Planning Commission Vote Report

Petition: **P.Z. 04-2018 West County Acres, Nardin Drive (R-2, PC to R-4)**: A request for a zoning map amendment from an “R-2” Residence District and “PC” Planned Commercial District to an “R-4” Residence District for a 20.7 acre tract of land located north and east of Swingley Ridge Road east of its intersection with Chesterfield Ridge Center Dr. (18S510164, 18S510142, 18S510131, 18S510119, 18S510098, 18S510229, 18S510021, 18S230158, 18S510010, 18S150043, 18S510087, 18S510108, 18S510120, 18S510153, 18S510175).

Re: P.Z. 04-2018 West County Acres, Nardin Drive (R2, PC to R4)
(Stock Project No. 217-6103)

Proposed Landscape

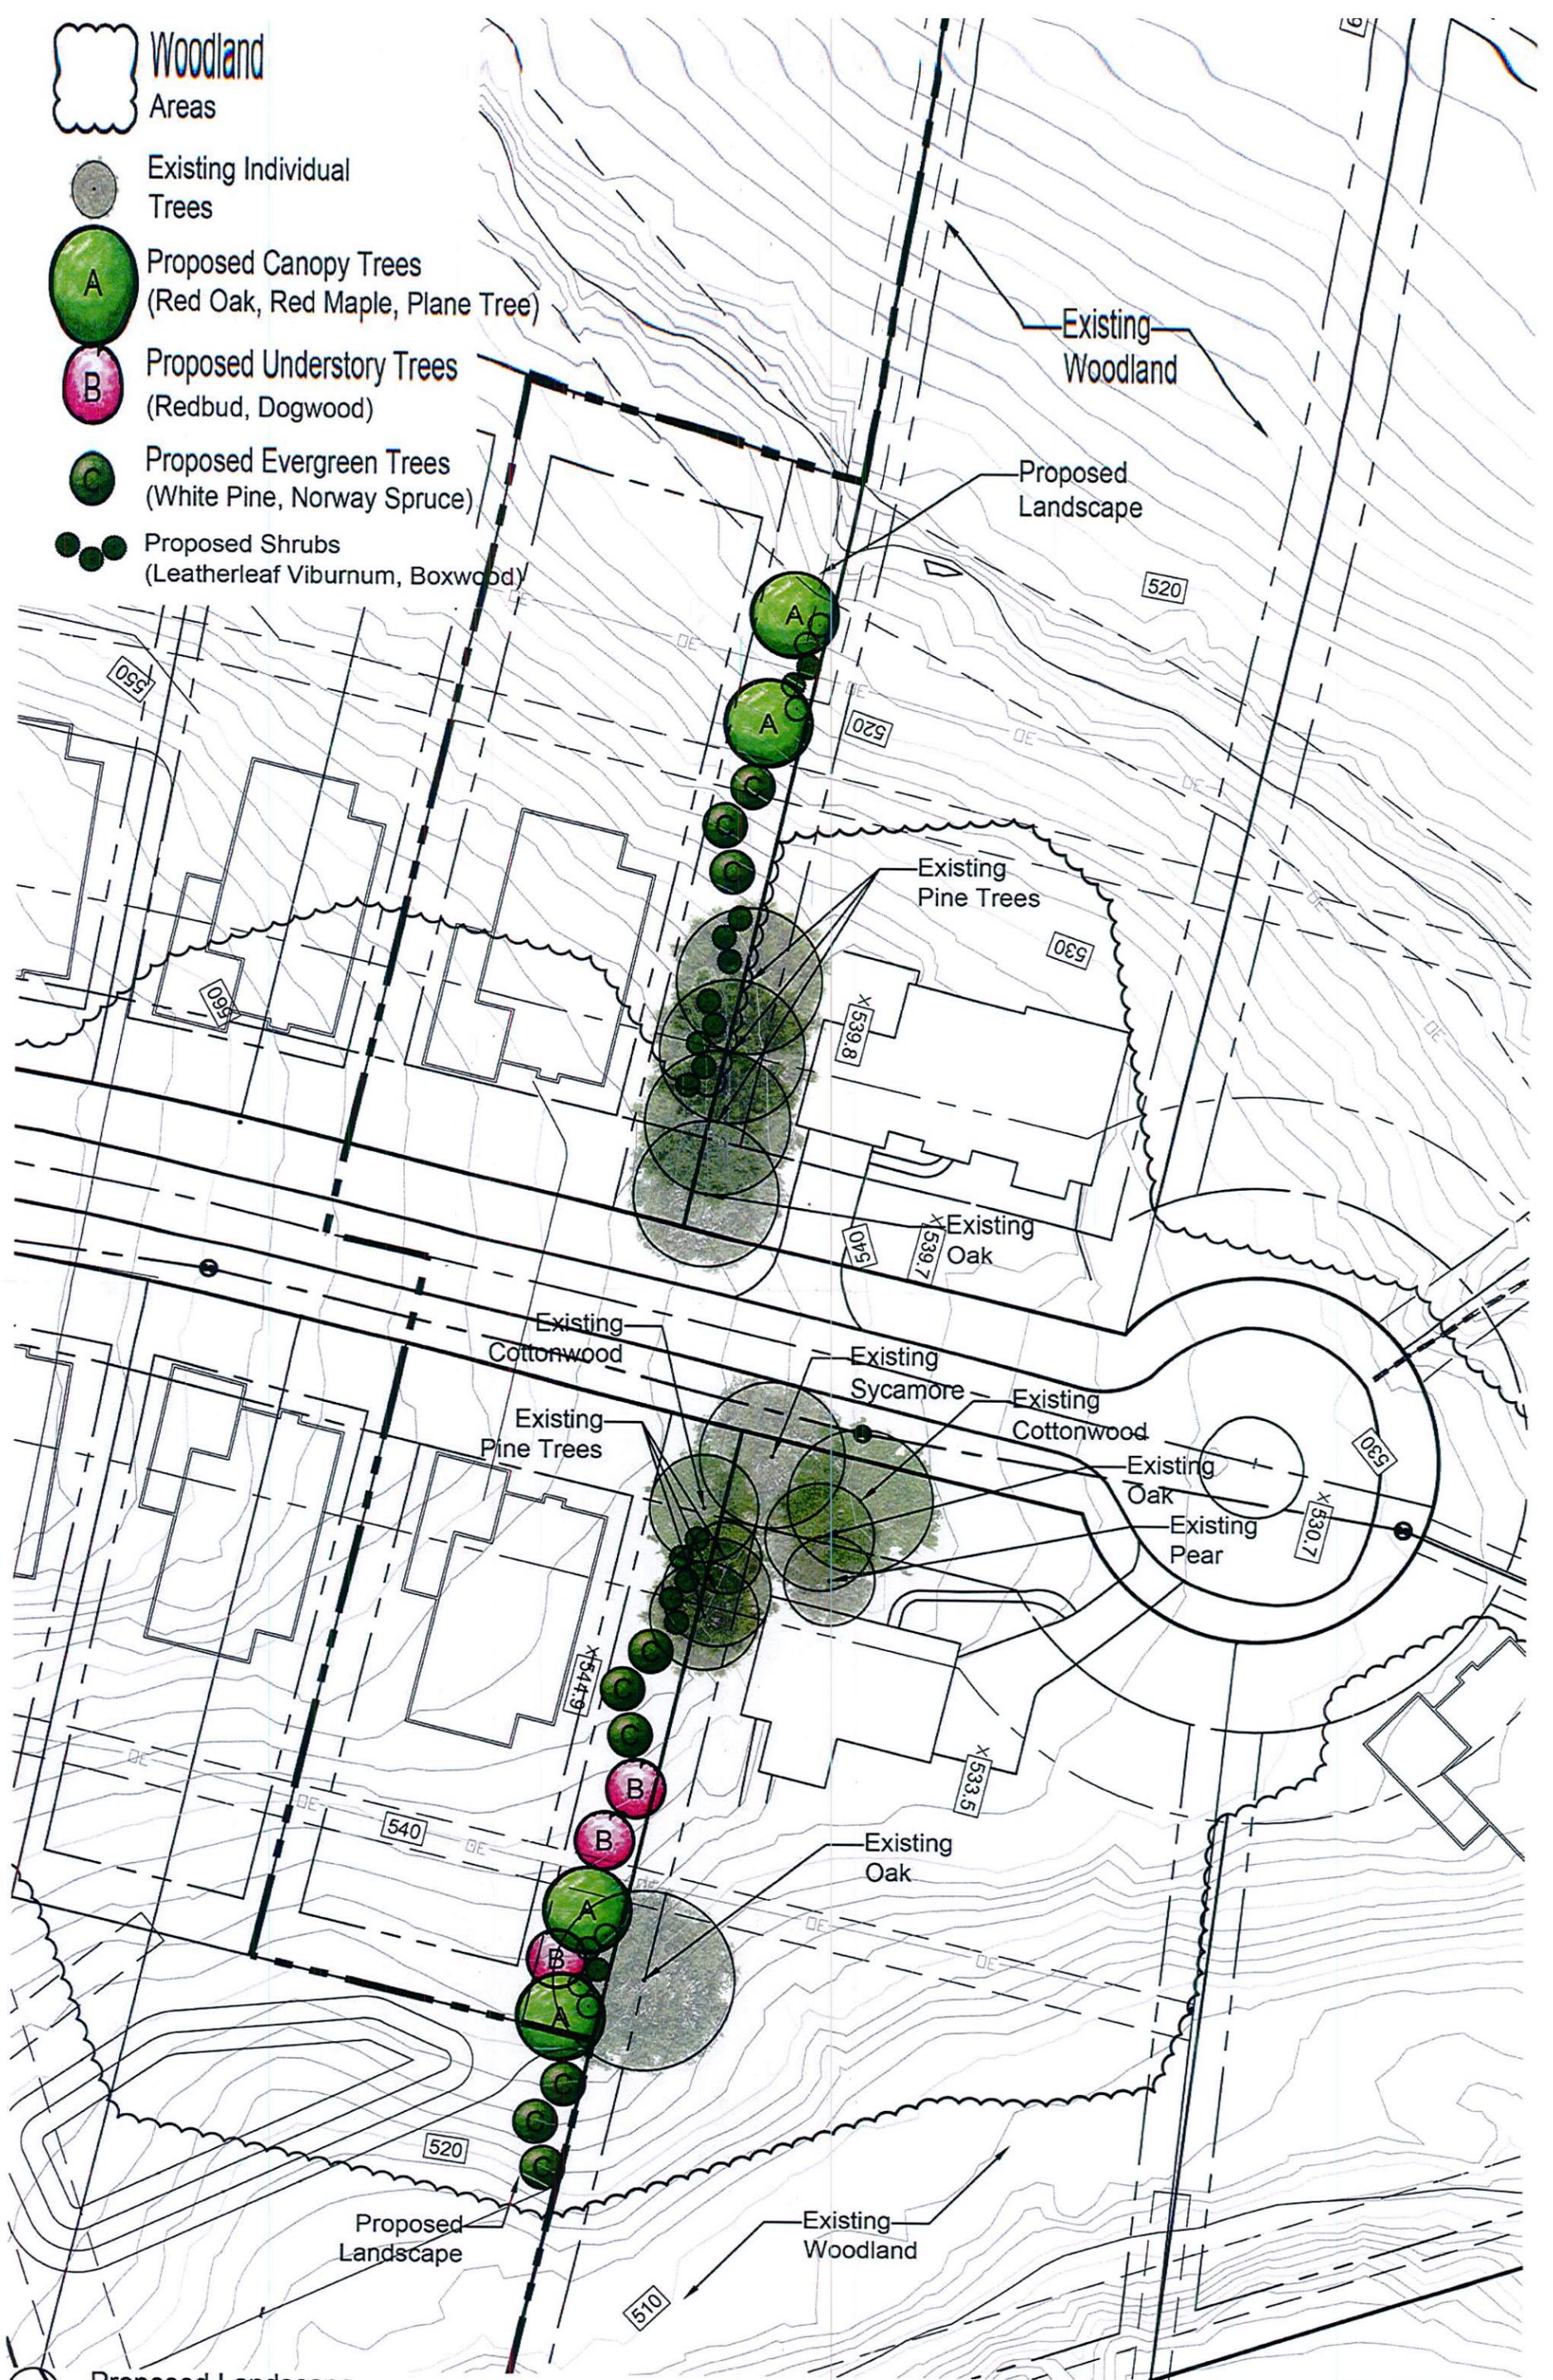
1. Transition of residential zoning districts: The Commission expressed a desire to see a transition of zoning districts to ensure that the character of existing homes north of the subject site is preserved.

Response: The proposed Two (2) Lots along the Southside of Existing Lots 19 & 23 will remain R2 Zoning. (See Revised Boundary Survey & Legal Description). A 20ft. landscape buffer will be provided along the southsides of existing Lots 19 & 23. The 20ft. landscape buffer will be a Landscape Easement on proposed Lots 21 & 22 in accordance with article 04 of the City's UDC pages 04-25 and 26.

Tree Stand Delineation
SCALE 1"=100'

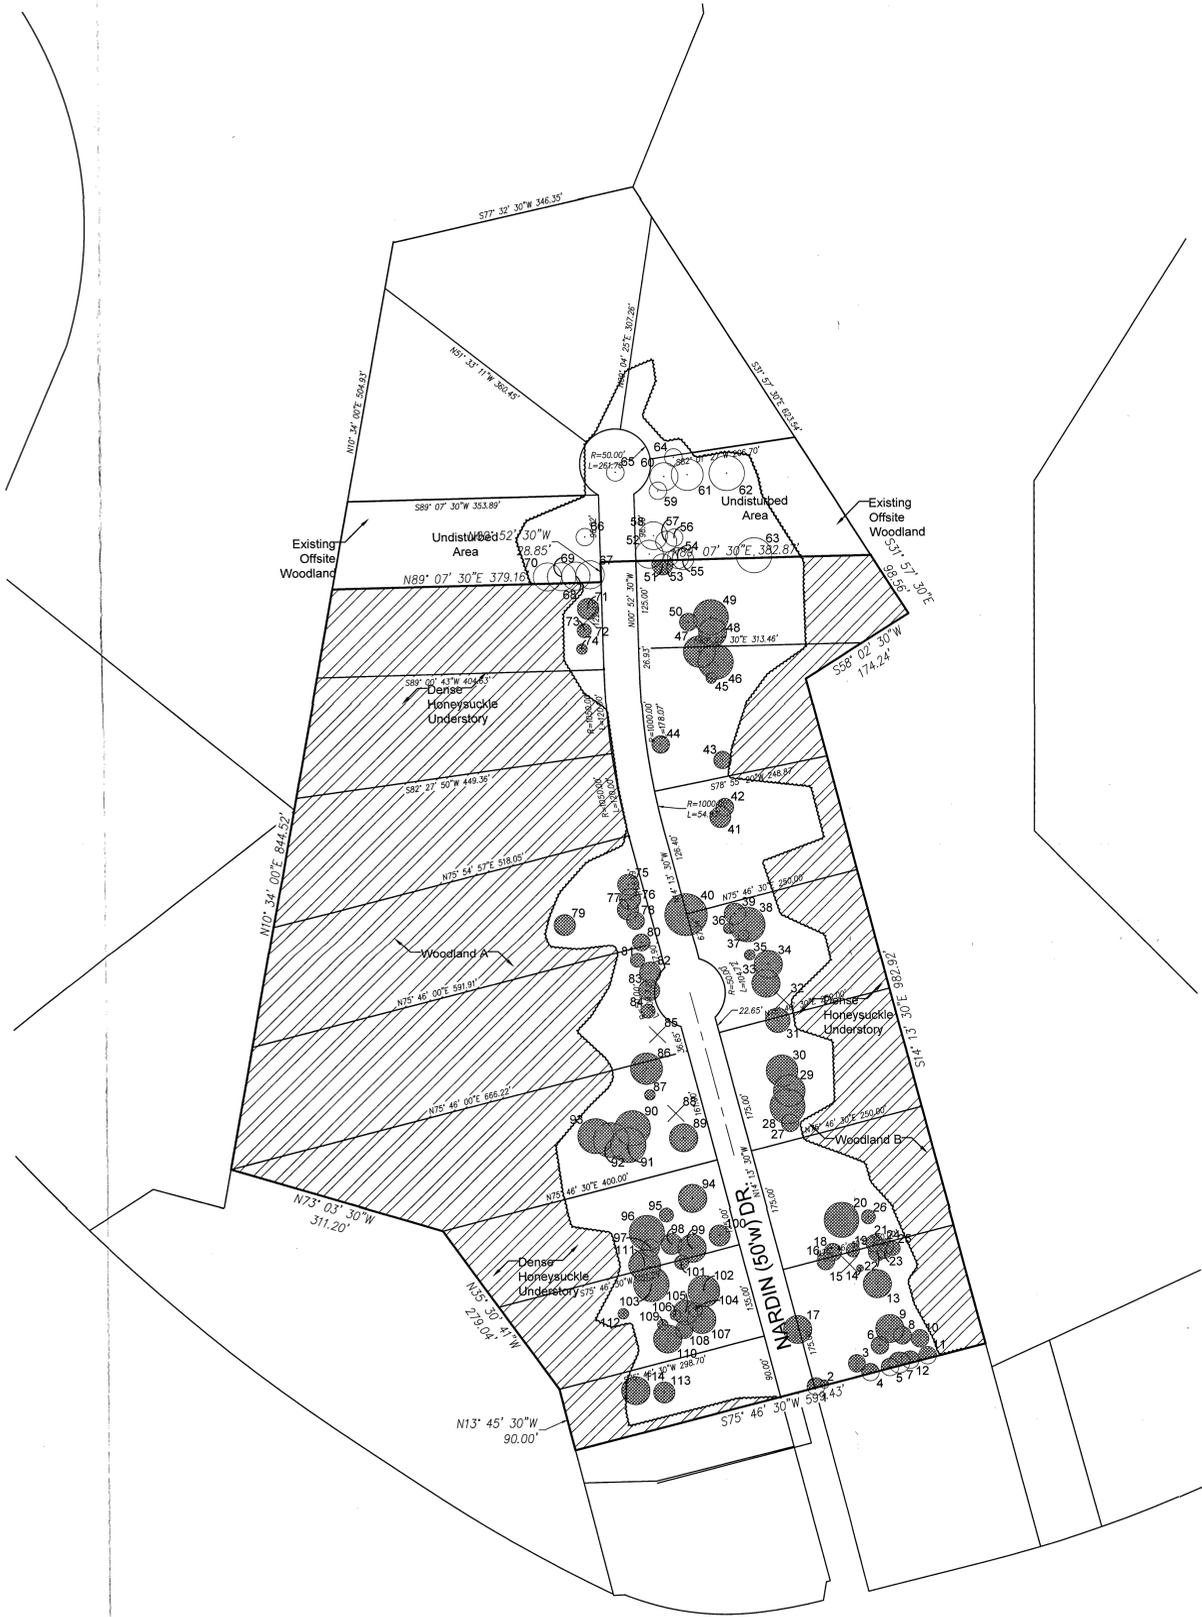
2. Consideration of Monarch Tree preservation: The Commission expressed a desire to see the monarch trees on the site preserved. Provide information about how tree preservation will be approached.

Response: We have reviewed the location of the four existing (4) Monarch Trees. They are located in close proximity to Nardin Drive. In order to reconstruct Nardin Drive to conform to the City of Chesterfield Horizontal and Vertical Alignments Standards, grading and widening will be required. Nardin Drive is currently 18-20 feet wide. The street will be replaced with a 26 feet wide street & sidewalks on each side of the street. It is unlikely "all" the trees can be saved, substantial tree canopy on Lots & around the perimeter of the lots will remain undisturbed as part of the project.
